FIRST REVIEW
WC³ Project #: 218-525-075
Weber County Project#: HSR 2018-03

Subject: Passage Land - SFD – Plan Review Comments 1st Review

Project Name: Passage Land - SFD

S3. Sheet S101:

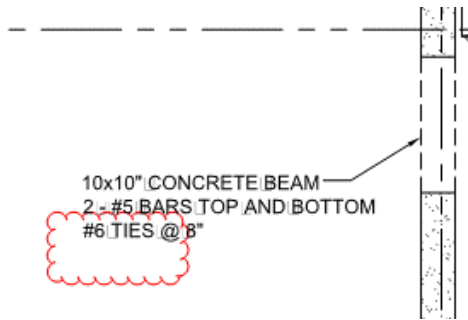
- A. Concrete beam 10"x10" shows #6 ties @ 8". This appears large for the beam size. Calculations were not found. Please verify constructability and shear analysis. (ACI 318 9.6.3)

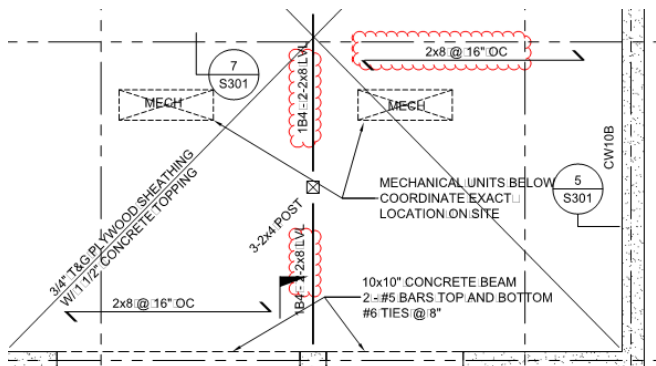
- B. Floor joists and beams show 2x8@16" o.c. and 2-2x8 LVL. A rough estimate for DL=45 psf, LL=40 psf suggests members are inadequate. Analysis does not appear to be available. Please verify design includes the concrete topping and mechanical units. (IBC 1604)

S4. Sheet S102:

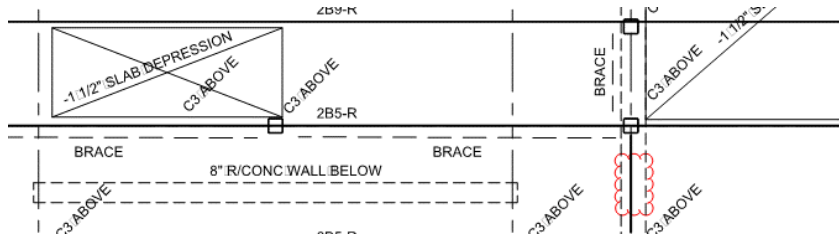
- A. GL-G, 10: Beam information appears to be missing. Please verify and provide on the drawing. (IBC 107)

S5. Sheet S103:

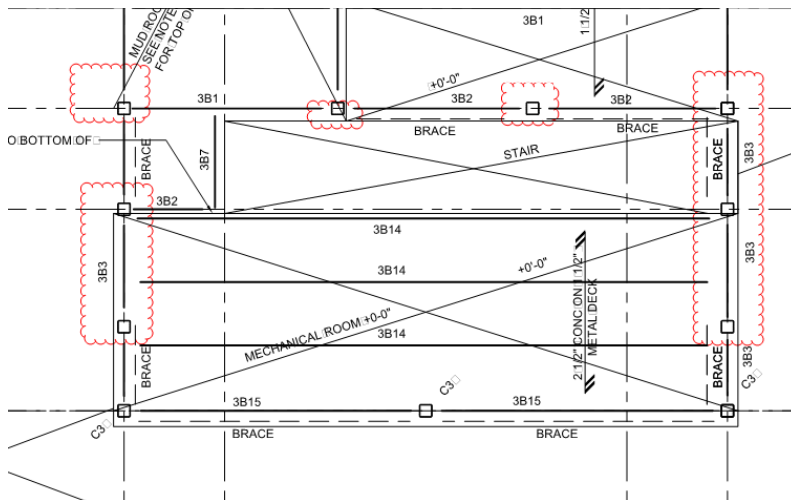
- A. Some columns appear to be missing information. Please verify and provide identification for columns. (IBC 107)

S6. Sheet S301:

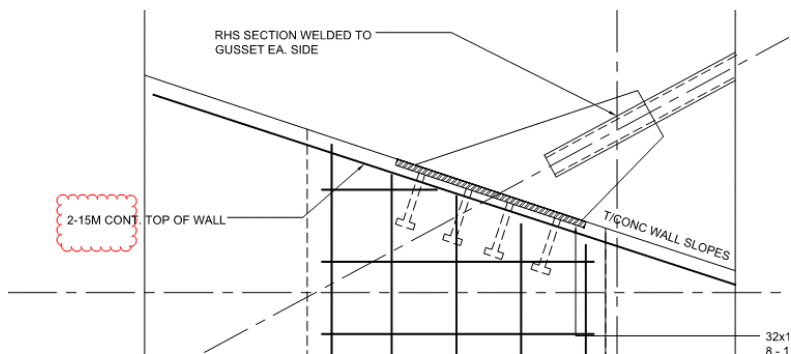
- A. Detail 2: Non-standard reference to rebar is indicated as 2-15M cont. Please verify and revise all references to standard notations. (IBC 107)

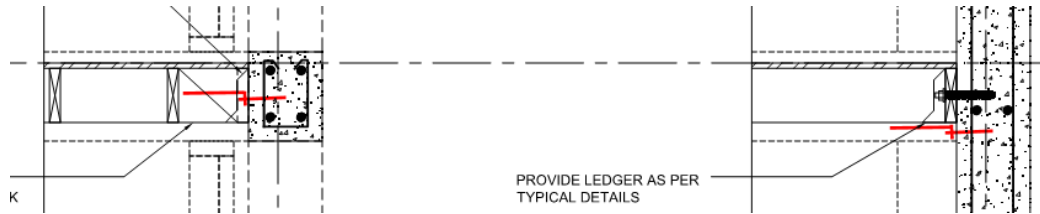
- B. Detail 4, 5, 7: Please verify that diaphragm is tied to the wall. Please consider providing tension device and blocking at suitable spacing. (ASCE 7 12.11)

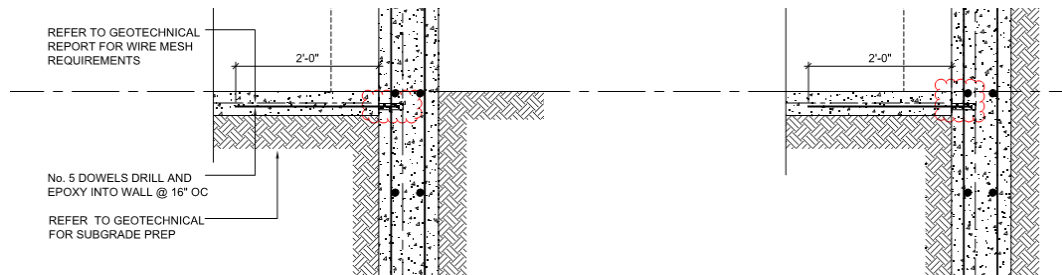
C. Detail 4, 5, 6, 7: Please verify and provide bar embed information. (IBC 107)

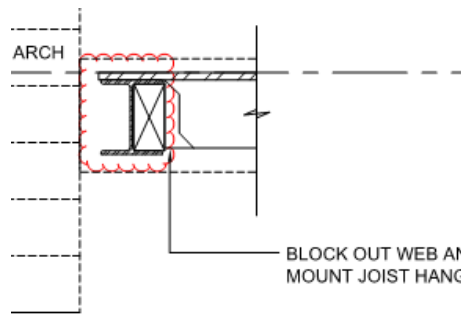
D. Detail 6: Please verify and provide block connection to steel beam. It does not appear to be provided. (IBC 107)

E. Detail 8:

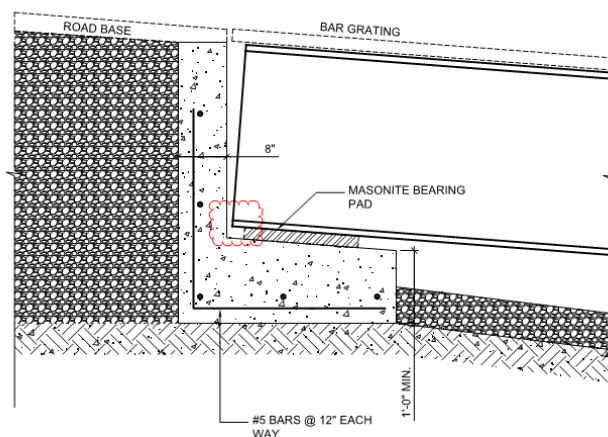
- I. Please verify and consider providing distance between steel and concrete. Please verify that steel expansion and seismic structural separation have been considered. (IBC 107, ASCE 7 12.12.3)
- II. Please verify frost depth is met for the concrete foundation. The geotech's report indicate 2" minimum below grade. (IBC 1809.5)
